UNITED STATES PATENT AND TRADEMARK OFFICE

APPLICATION NO.	FILING DATE	FIRST NAMED INVENTOR	ATTORNEY DOCKET NO.	CONFIRMATION NO.
10/729,932	12/09/2003	Hul Chun Hsu	OP-094000506	2437
46103	7590	05/30/2008		
HDSL 4331 STEVENS BATTLE LANE FAIRFAX, VA 22033			EXAMINER DUONG, THO V	
			ART UNIT 3744	PAPER NUMBER
			MAIL DATE 05/30/2008	DELIVERY MODE PAPER

DETAILED ACTION

Figure A: The modified figure corresponds to figure 5 with limitation shown

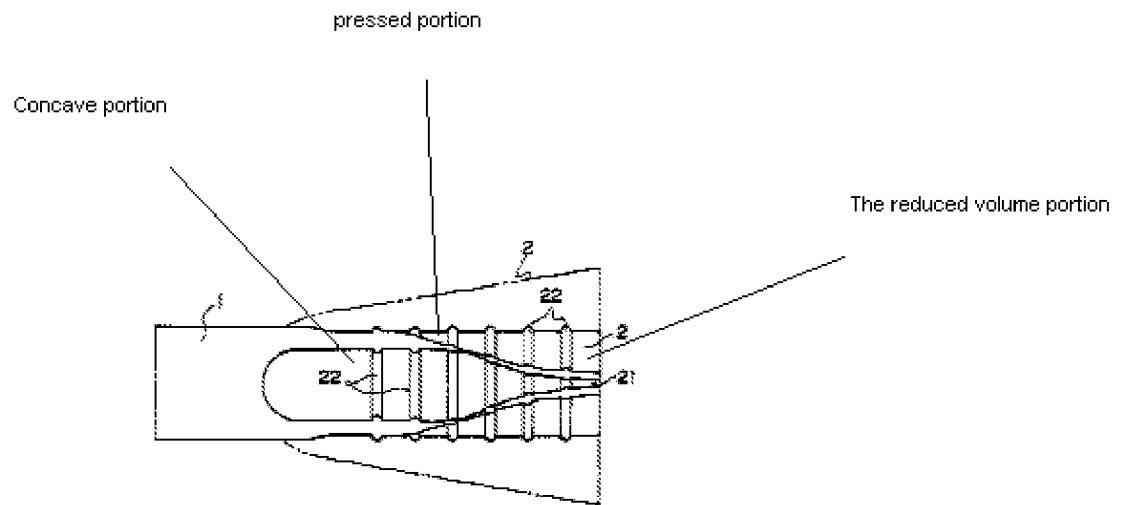
Claims 1 and 8-10 are rejected under 35 U.S.C. 102(b) as anticipated by Yumiko et al. (JP 406106269A). Yumiko discloses (figures 1-10 and figure A bellow) a circular tubular heat pipe having a sealed structure closing a distal opening end thereof, comprising a concave wall portion formed on the heat pipe bellow and near the distal opening to form an overlapping wall from the concave wall portion to the distal opening; a pressed recess portion formed on the concave wall portion adjacent to the distal opening, the pressed recess portion being an arch shape in cross section (see figure 4 and 7); wherein the pressed recess portion near the distal end

opening is inward pressed to form a volume reduced portion (21 in figures 5 and 7); and a sealed welding portion (2) formed at the pressed recess portion, the reduced volume portion and the distal end portion by ultrasonic welding forming spots (22) (figure 2). Furthermore, regarding claims 9-10, the methods of forming the device "is spot welded" and "is ultrasonically welded" are not germane to the issue of patentability of the device itself. Even though product-by-process claims are limited by and defined by the process, determination of patentability is based on the product itself. The patentability of a product does not depend on its method of production. If the product in the product-by-process claim is the same as or obvious from a product of the prior art, the claim is unpatentable even though the prior product was made by a different process." In re Thorpe, 777 F.2d 695, 698, 227 USPQ 964, 966 (Fed. Cir. 1985). In this instant case, the product-by-process claim is the same as or obvious from the heat pipe of Yumiko, the claim is unpatentable even though the prior product was made by a different type of welding. With respect to the limitation of "a volume reduced portion having a cross section of an unsymmetrical curled shape", Yumiko discloses (figure B) that the volume reduced portion having a cross section of an unsymmetrical curled shaped along its X-axis, where above and below cross section of the reduced portion along X-axis is different.
